GEORGETOWN-SCOTT COUNTY PLANNING COMMISSION

AGENDA

January 11, 2018

RAINS PROPERTY
Staff Report to the Georgetown-Scott County Planning Commission
January 11, 2018

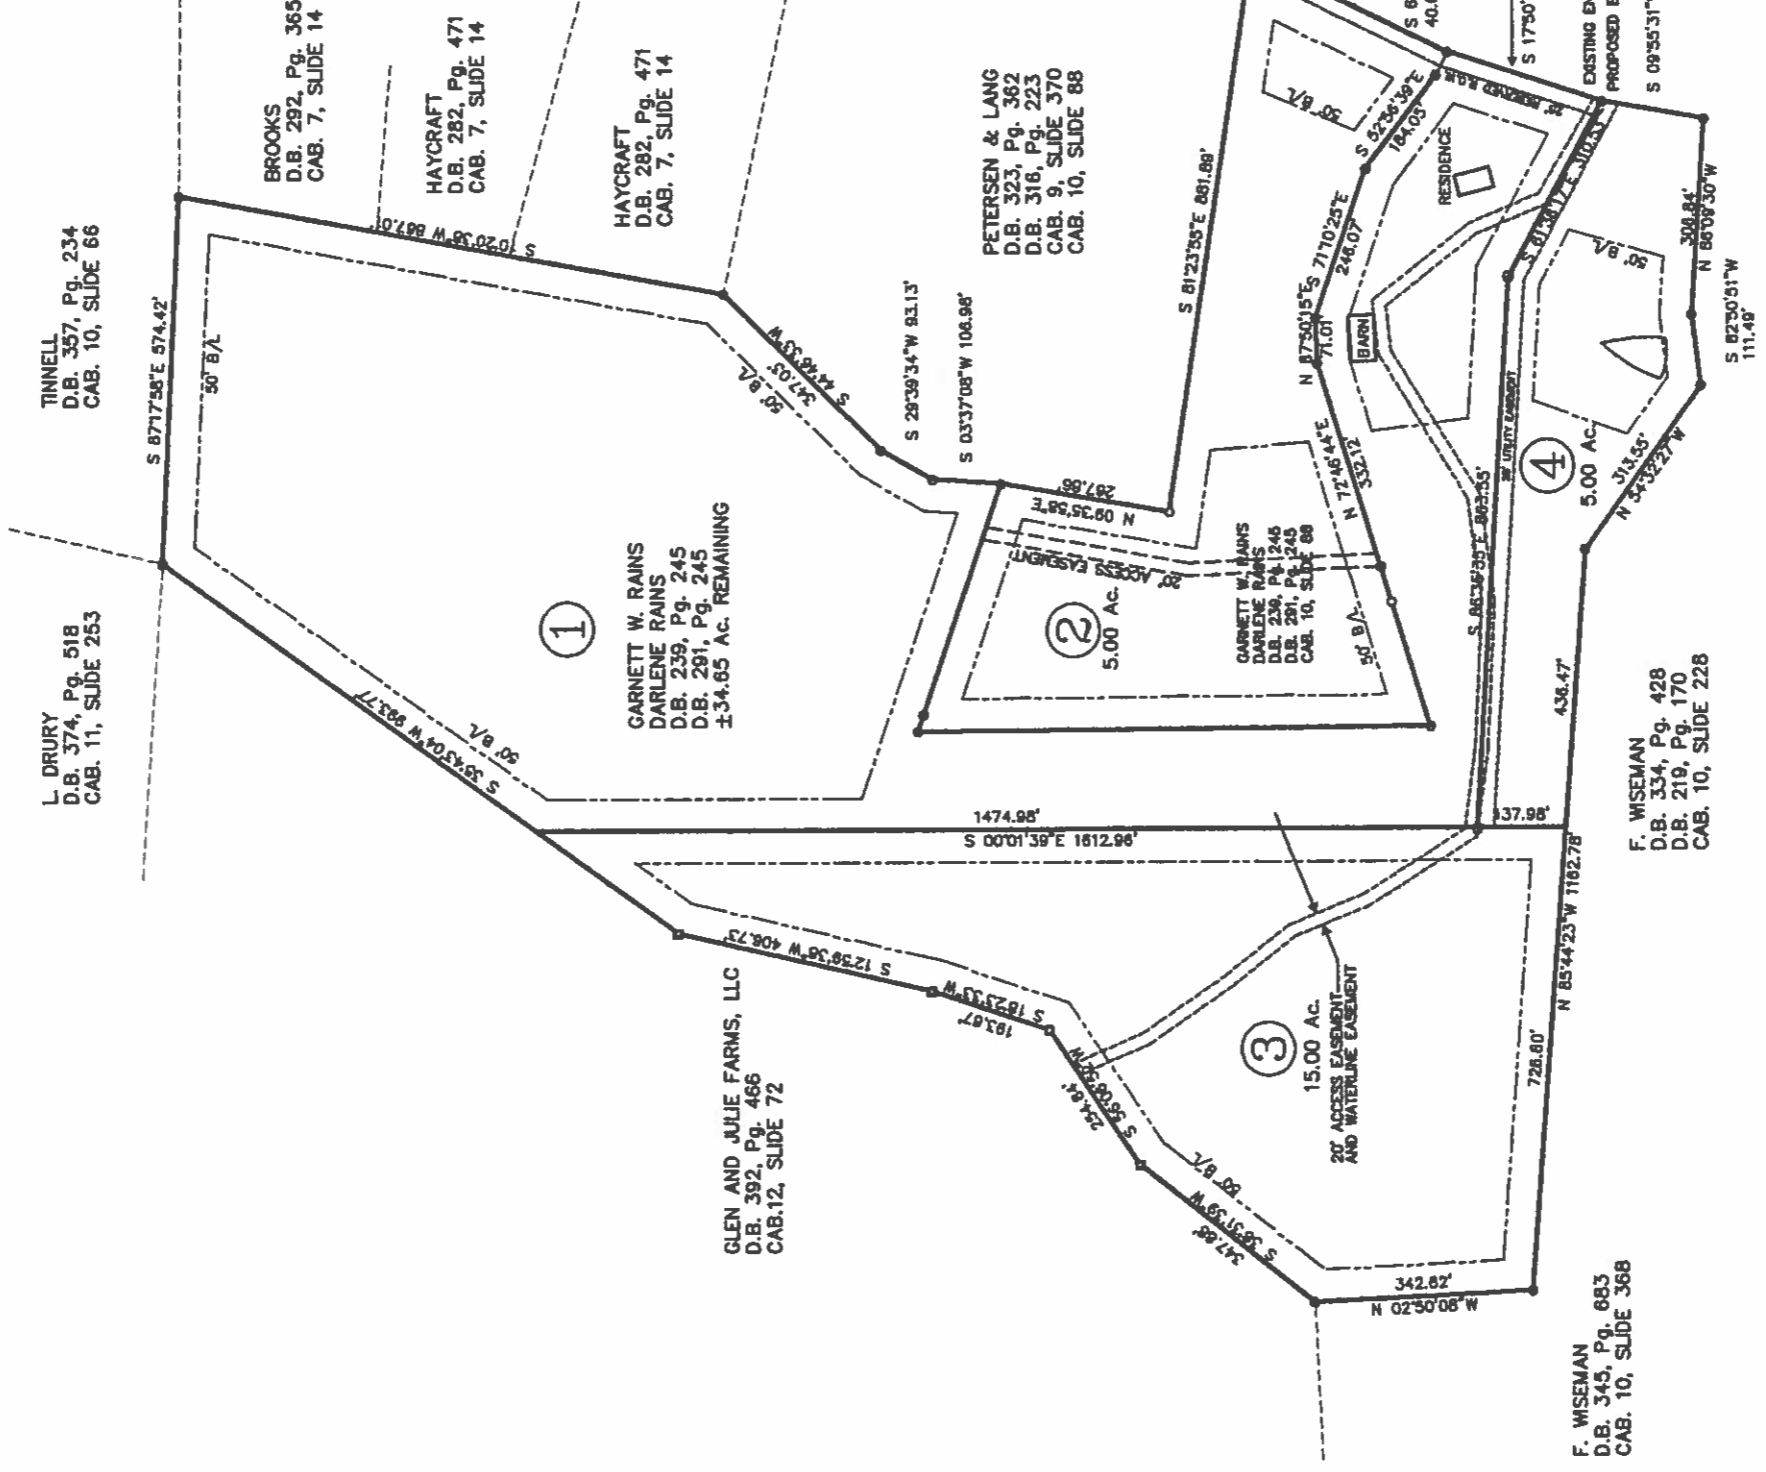
The proposed subdivision meets all planning requirements at this time. All tracts show the required 50-foot setbacks on all property lines and have at least 250 feet of width at the building line. The Health Department will need to conduct a site evaluation for the newly configured tracts to certify that an on-site septic system is feasible, but have not indicated any anticipated problems.

6. Prior to (as part of) the Final Subdivision Plat approval, the total acreage and the purpose of the plat shall be corrected.
7. Final Subdivision Plat shall show only show a maximum of three users for each access easement.

MALLARD POINT TRACT 4
Staff Report to the Georgetown-Scott County Planning Commission
January 11, 2018

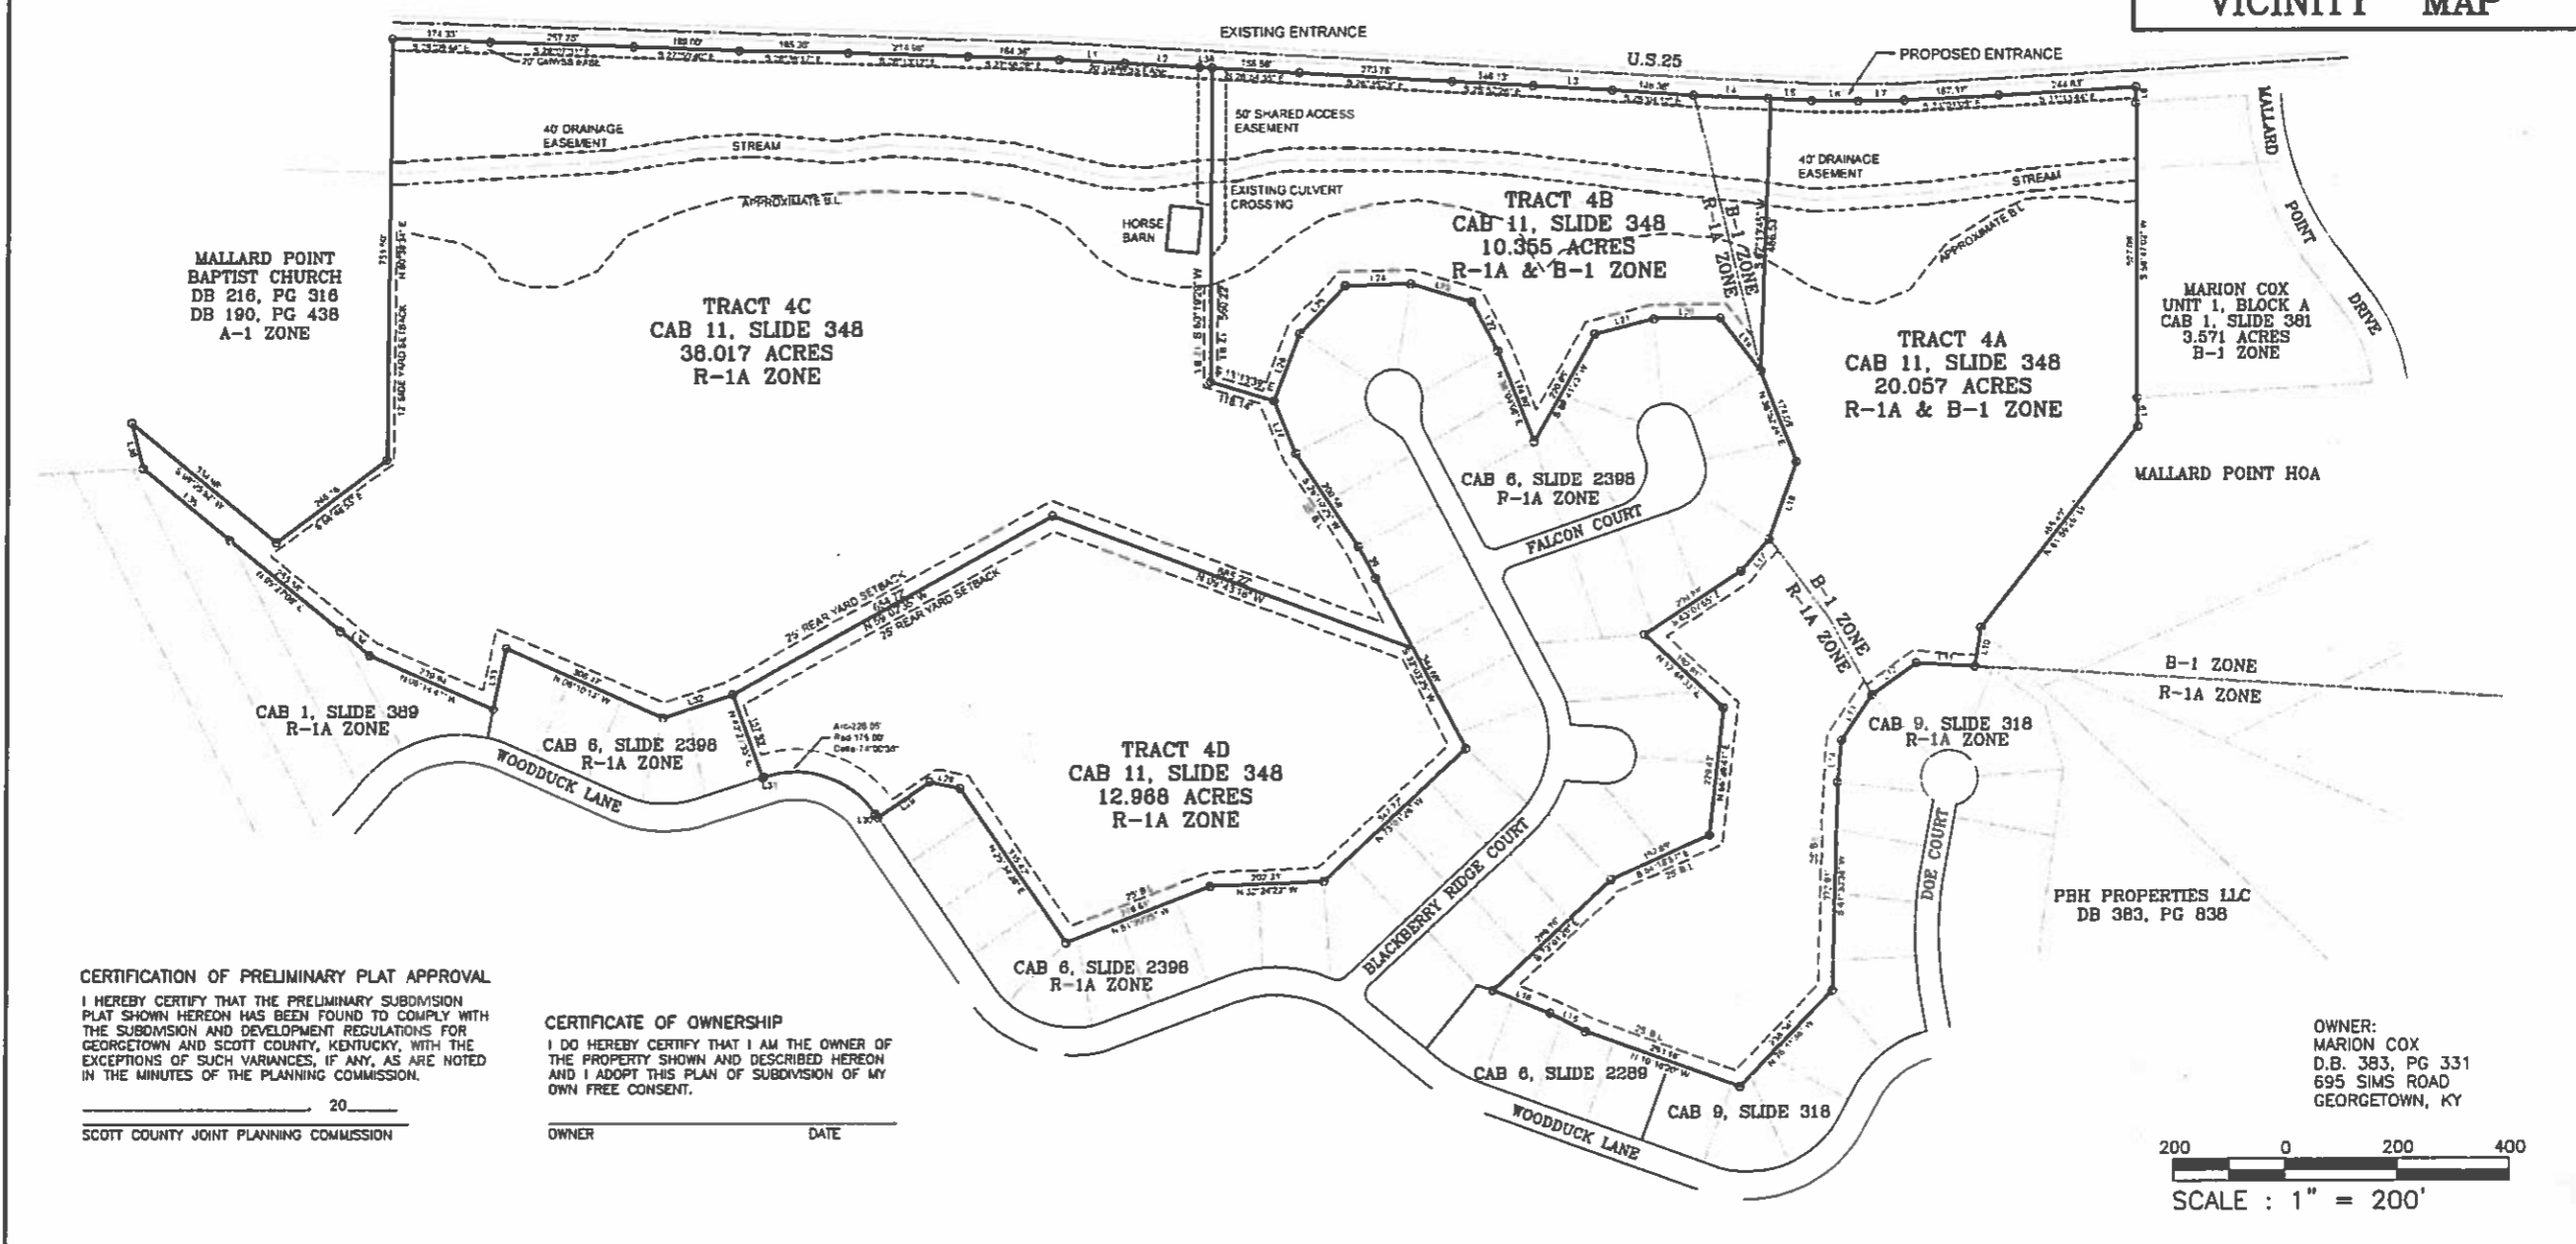
The Final Subdivision Plat will need to show the setbacks on the lots or list the setbacks in a table.

1. The Final Subdivision Plat will establish an increased setback from US 25, including the notes listed on page 2 of the staff report.
2. The proposed driveway shown for Tract 4A, shall be restricted to use only by a single residence.
3. The Final Subdivision Plat will require certifications from water, sewer/Health Department, and electric utilities.
4. Prior to (as part of) the Final Development Plan approval, the applicant shall provide the Planning Commission staff (GIS division) with a digital copy of the approved plan.
5. All applicable requirements of the *Zoning Ordinance* and *Subdivision & Development Regulations*.
6. The Preliminary Subdivision Plat approval is valid for two years, subject to the requirements of Article 306 of the *Subdivision and Development Regulations*.

3rd AMENDED PRELIMINARY DEVELOPMENT PLAN
LIFESTYLE COMMUNITIES
 THE MILLS APARTMENTS
 1143 OLD OXFORD DRIVE

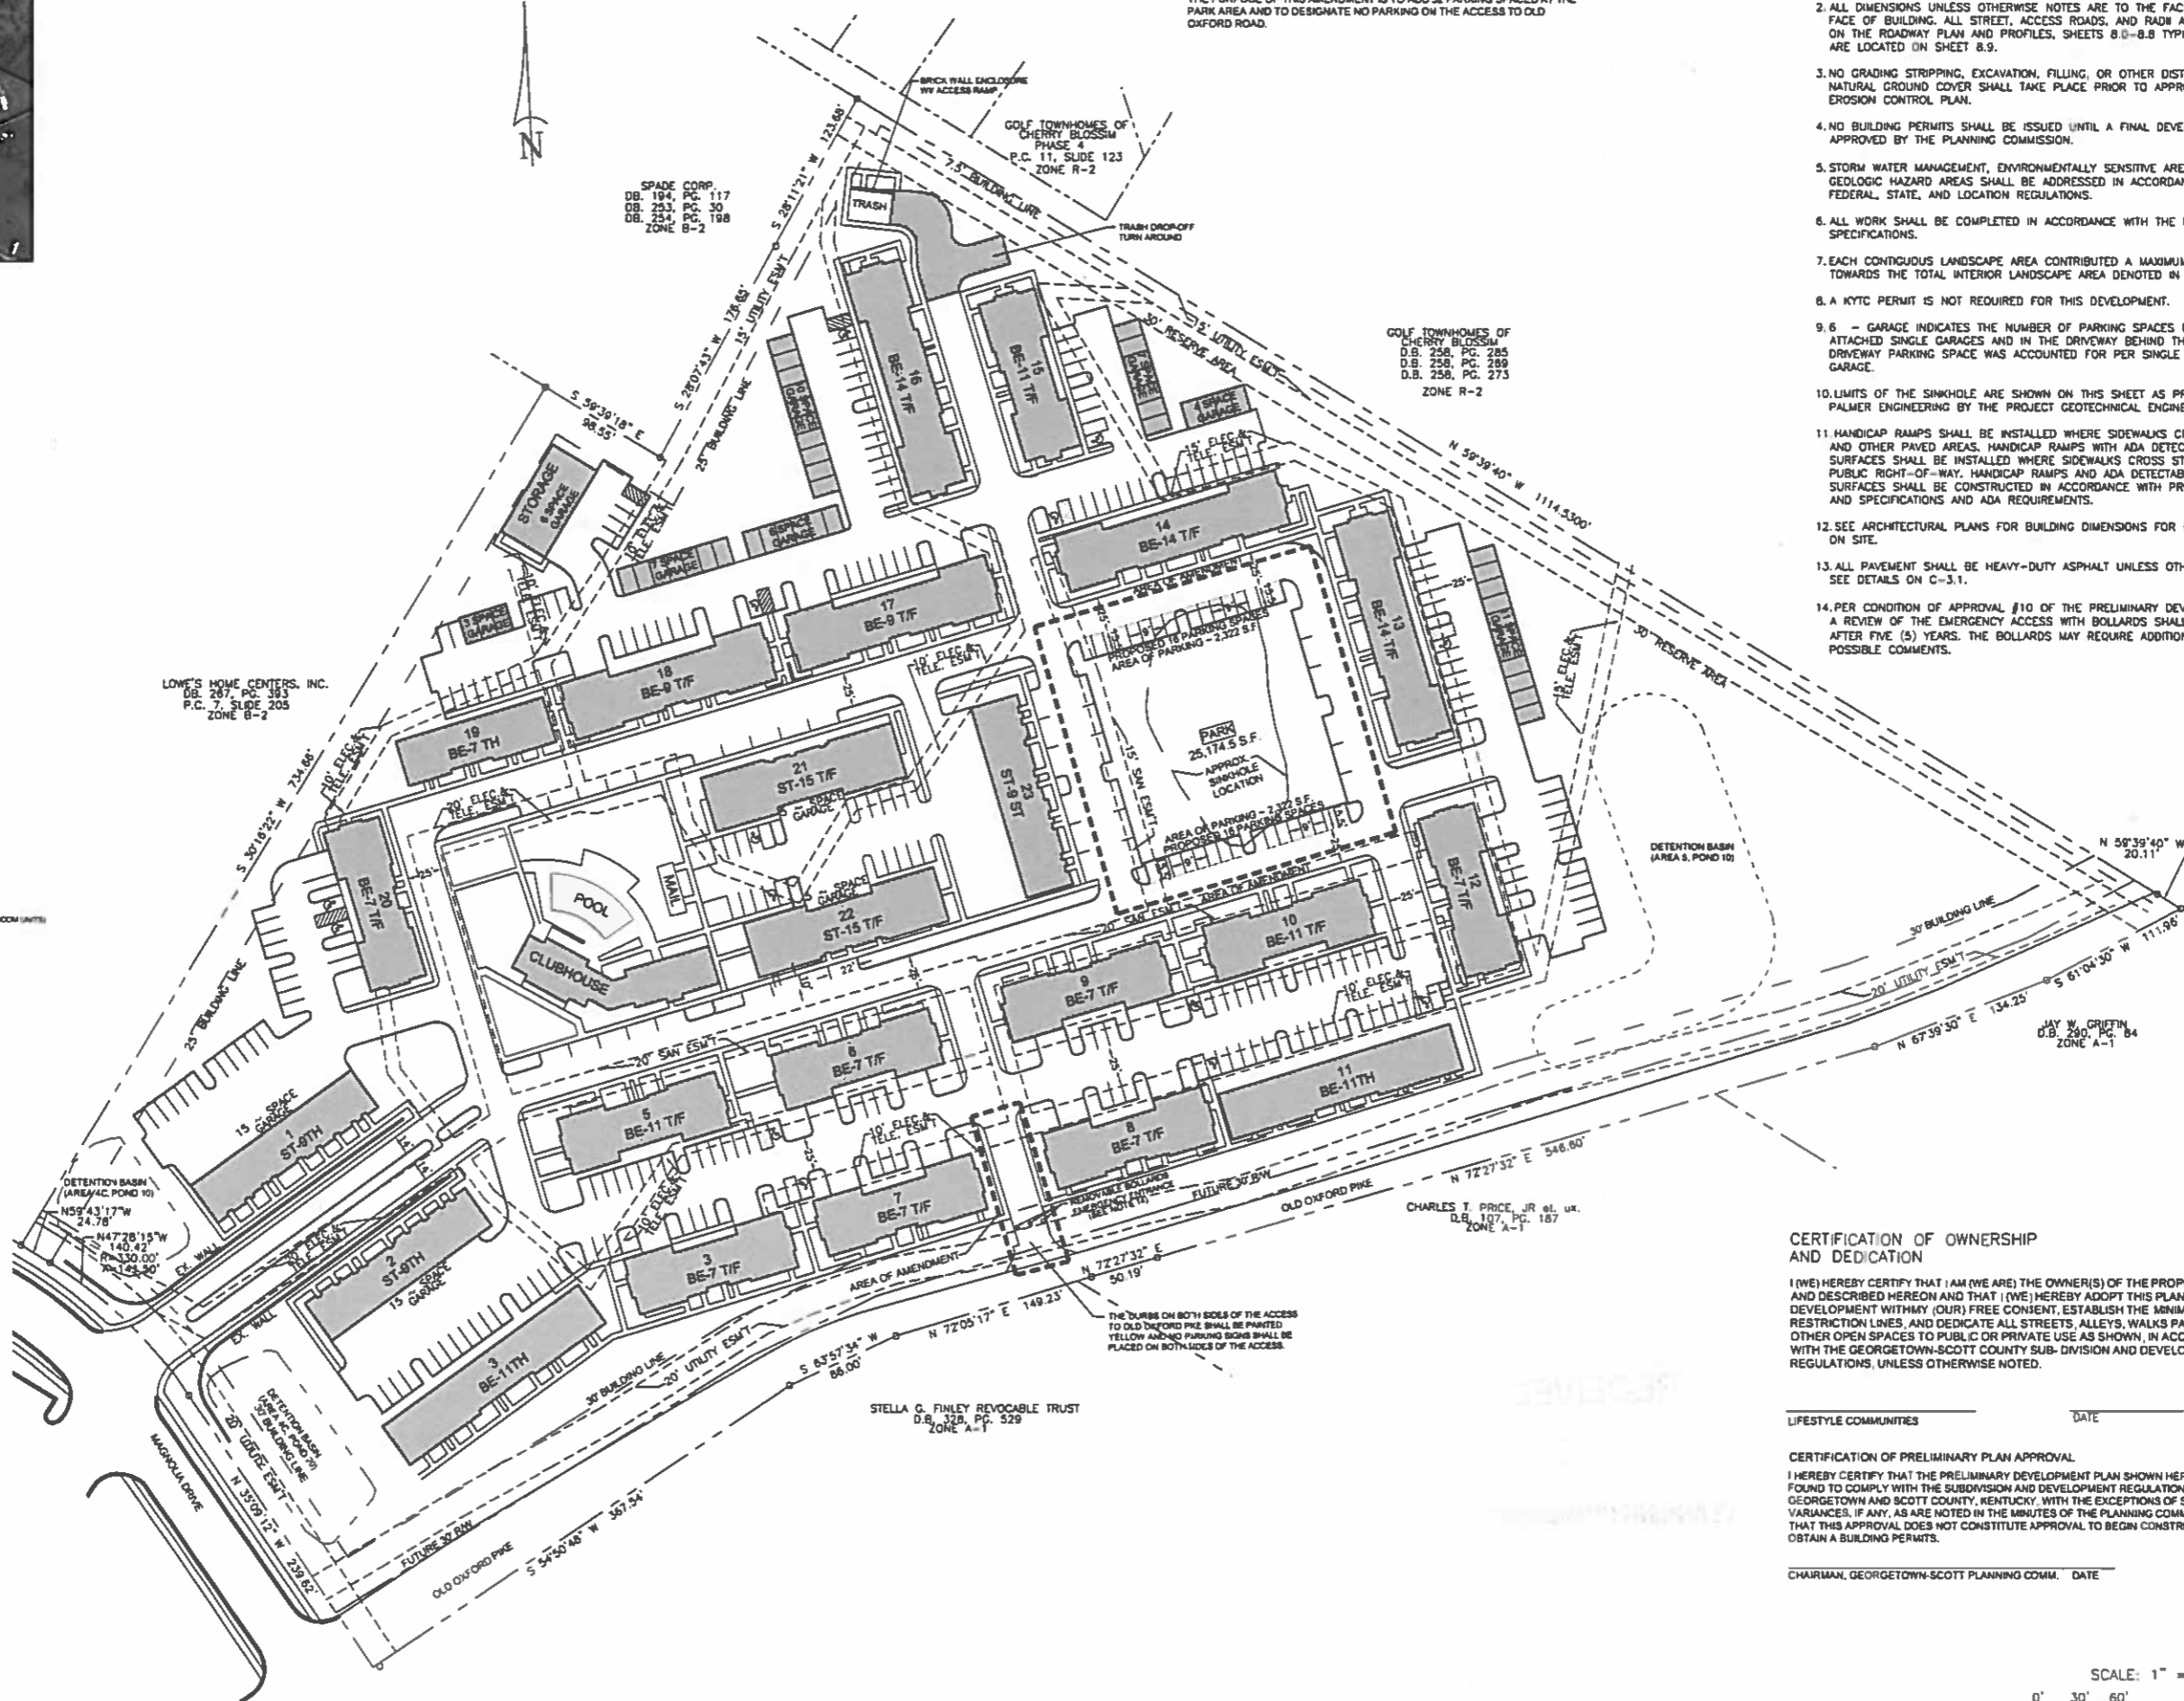
A park is located on a previously identified sinkhole area. The Subdivision Regulations require sinkholes to be identified on the Development Plan but prohibit treatment, filling, or being enclosed. In addition, no structure may be located within the defined limits of a sinkhole. The Applicant requested a waiver for the treatment and remediation of the sinkhole, at the time of Preliminary development Plan approval in 2010, in order to construct the proposed park. In general, staff agreed that it was best to close off access to the sinkhole. Staff approved the park as an acceptable use for the sinkhole site.

The sinkhole was remediated when the apartments on site were constructed. The amended plan adds additional parking on the perimeter of the former sinkhole open space area. The parking is proposed at the perimeter of the park on its north and south sides and should not impact the sink hole area. The applicant will be required to meet all requirements of the Stormwater Regulations and the Environmentally Sensitive Lands Ordinance. The applicant will also be required to show that the increase in impervious area can be accounted for in the stormwater design for the site and the proposed parking areas can be safely constructed in the remediated sinkhole area.

The apartments were constructed with an entrance on Old Oxford Road with bollards placed across, making the Old Oxford entrance an emergency access only. The Subdivision Regulations require that multiple family developments over 100 units in size have at least two entrance points. At TRC for the Preliminary Development Plan review in 2010, staff requested that turn lanes on Old Oxford Road be added. The Applicant pointed to the previous traffic study that showed that turn lanes were not justified and that the single entrance will allow a Level of Service B on Magnolia Drive. The project was approved by the Planning Commission in 2010 with the bollards in place, with no improvements made to Old Oxford Road and the condition that it be evaluated in five years time.

It has been five years since the construction of the apartments and the Georgetown Fire Department and the City Engineer and Public Works Departments have no issues with the bollards remaining in place. It is recommended that the bollards be allowed to remain until such time as a request comes from the City for opening of the second entrance. The Amended Final Development Plan needs a note that requires turn lanes on Old Oxford Road to be evaluated and constructed if the bollards are ever removed in the future.

APPROVAL of Amended Final Development Plan for 32 additional parking spaces around the remediated sinkhole area. Approval shall be subject to:

1. All previous applicable requirements of the previous rezoning approval (ZMA-2008-35) and Preliminary Development Plan (PDP-2010-12).
2. An updated stormwater management plan shall be provided to address the proposed new impervious areas.
